## CONSTRUCTION DOCUMENTS REVIEW

2/16/06

RE: QUIZNOS SUB  
Byram Business Center #5989  
102-106 Byran Business Center  
Byram, MS 39272

**EQUIPMENT PLAN**

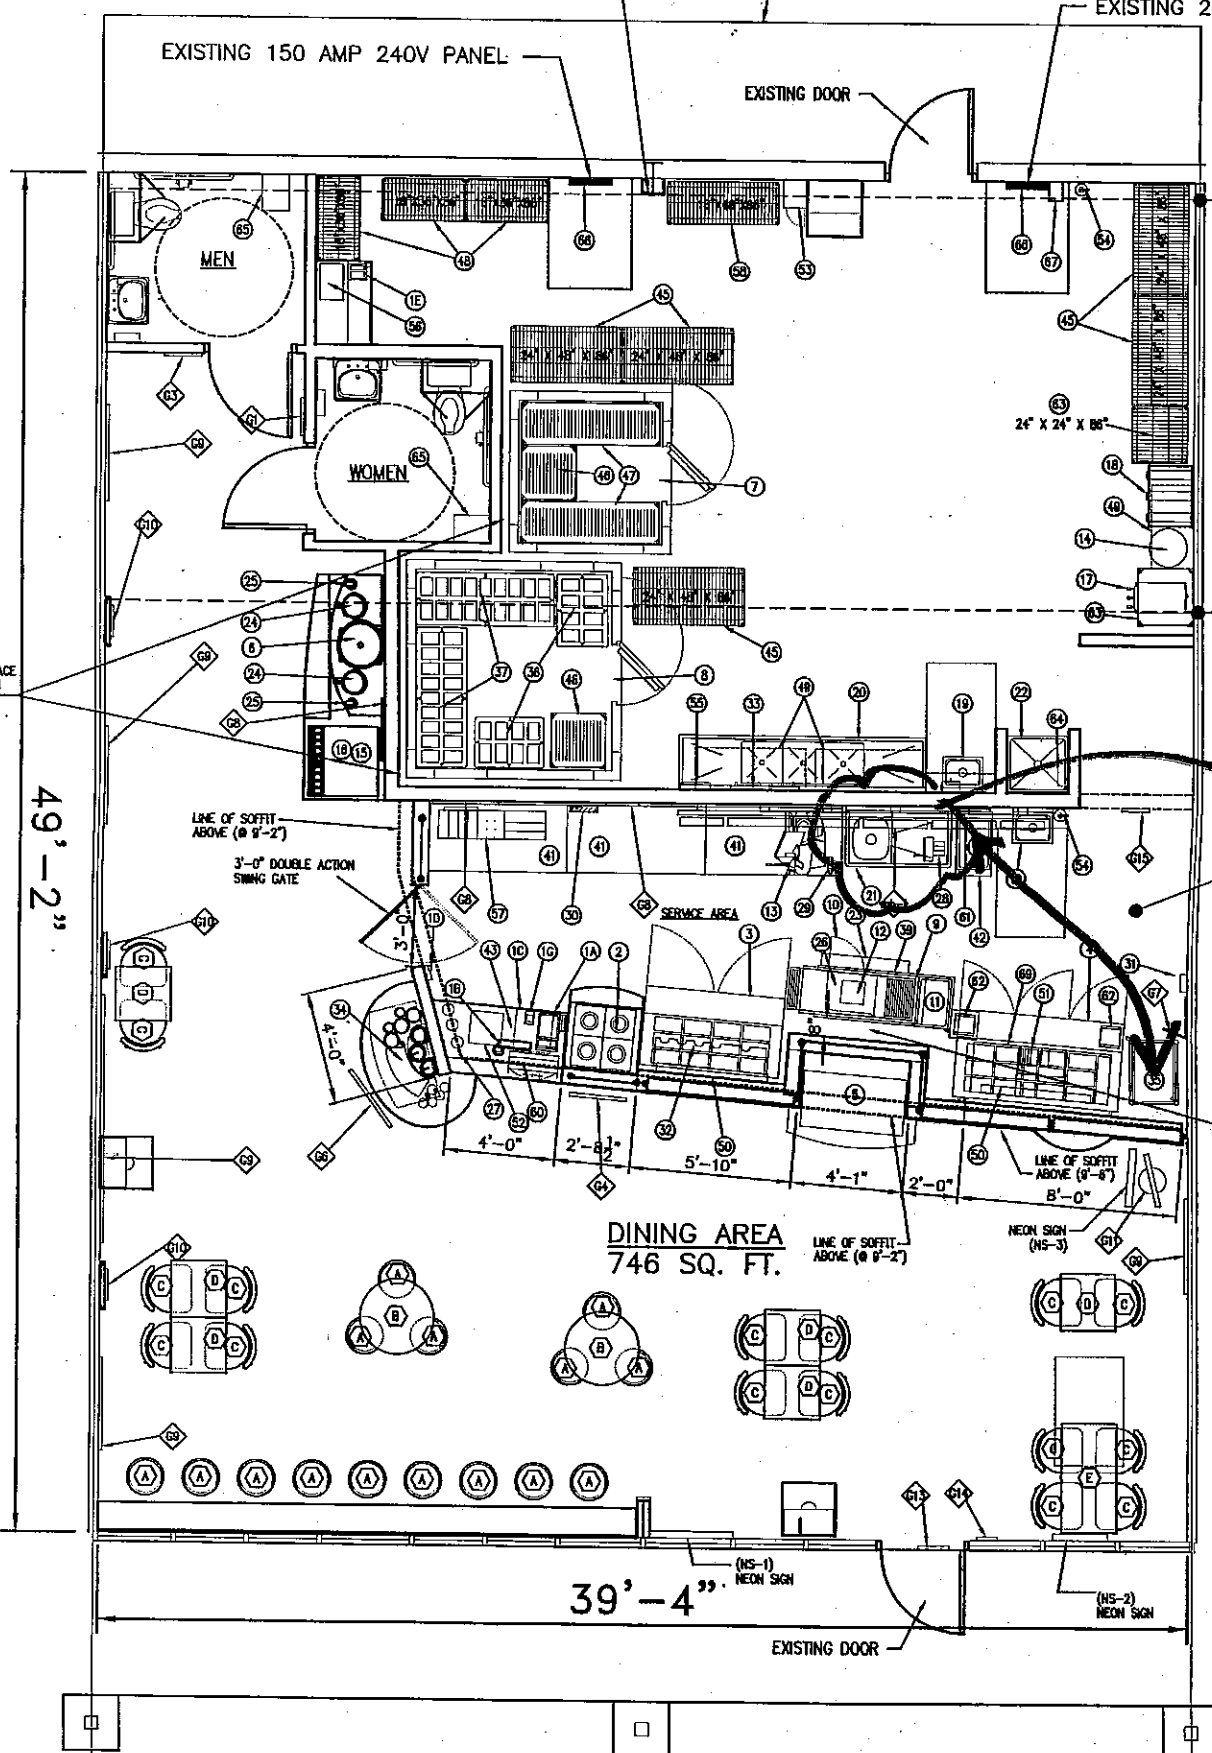
*Left Drain*

CEILING HEIGHT  
EL @ 9'-8" VERIFY

240V (VERIFIED)  
TOASTER MUST BE LOCATED  
6" TO 8" AWAY FROM SNEEZE  
GUARD TO PREVENT GLASS  
FROM BREAKING

**REFLECTED CEILING PLAN**  
 SCALE: 3/16" = 1'-0"  
 NORTH

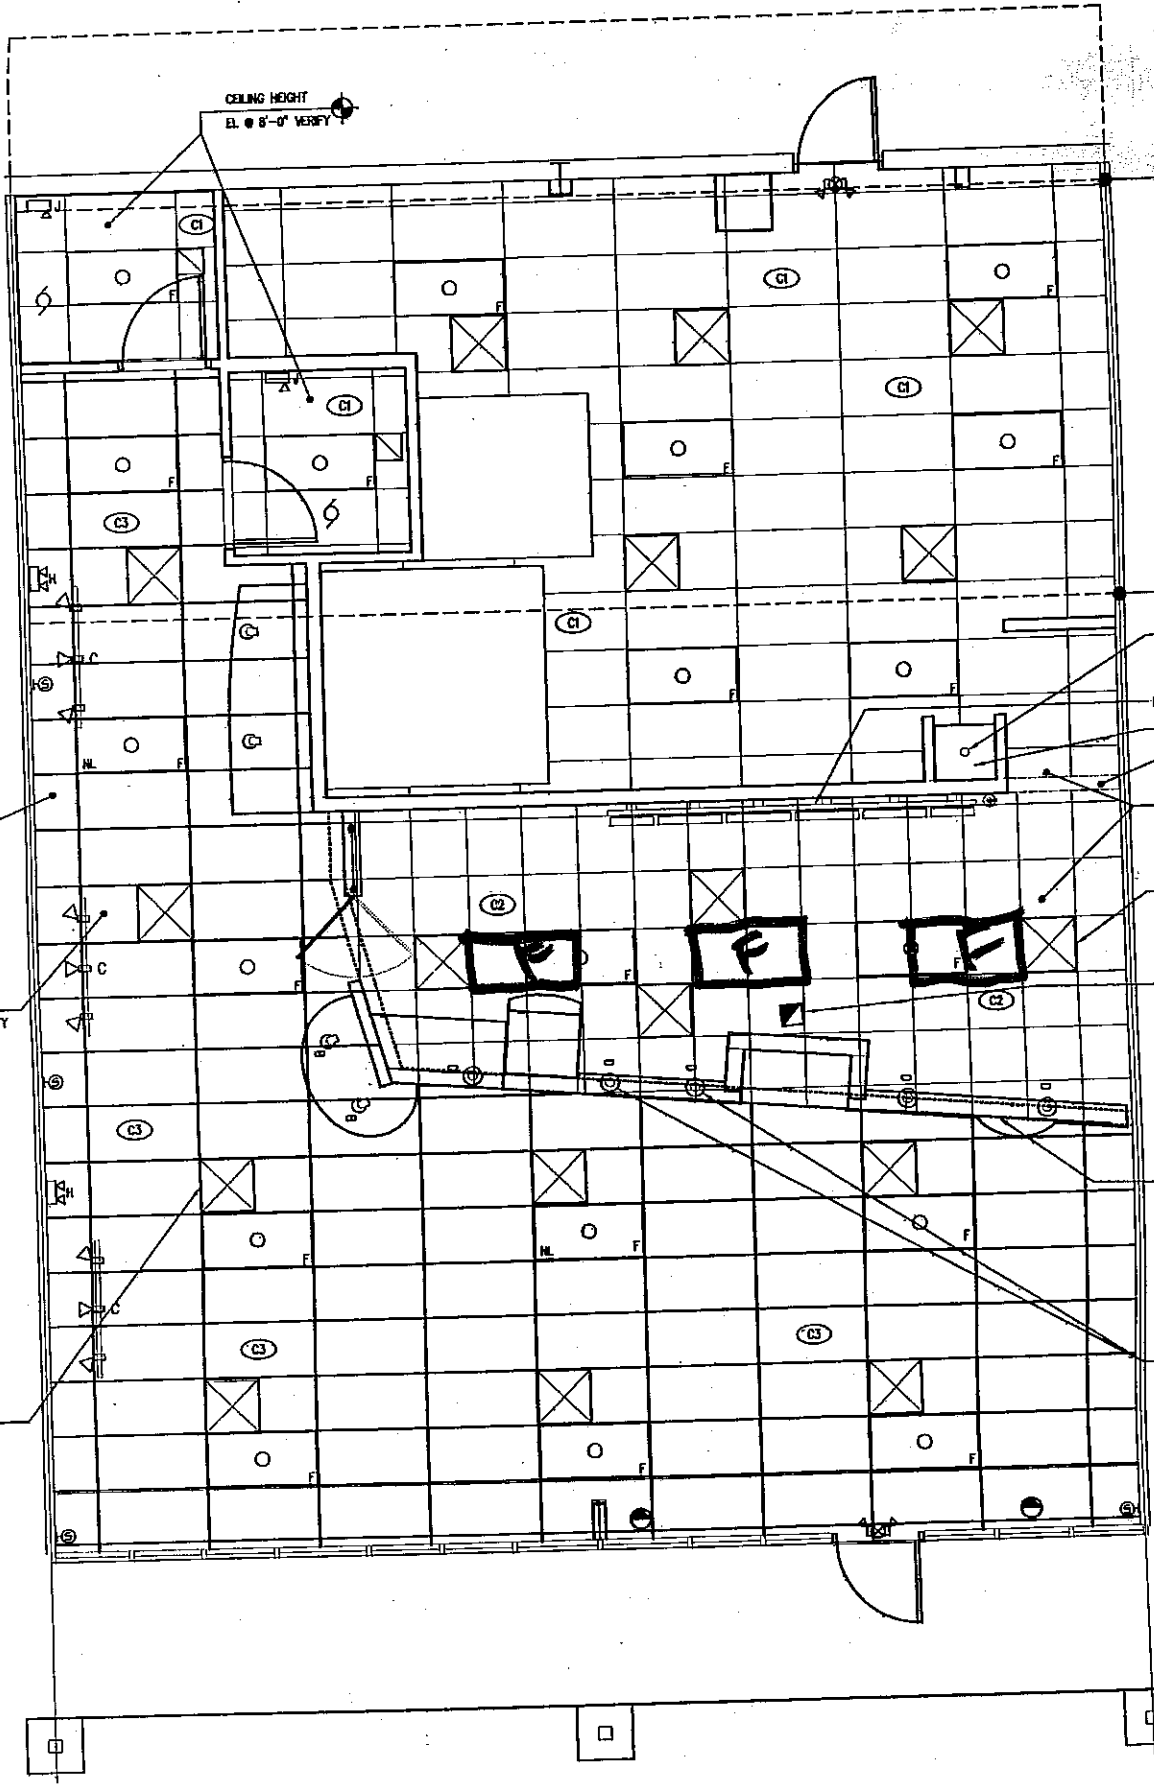
GAS VENT  
 MENU BOARD BELOW  
 CEILING ACCESS  
 ABOVE WATER HEATER  
 HEADER HEIGHT  
 EL. @ 8'-8" VERIFY  
 CEILING HEIGHT  
 EL. @ 9'-8" VERIFY

COORDINATE LIGHTS AT  
 SOUP STATION TO NOT  
 INTERFERE WITH SOUP PUCK.
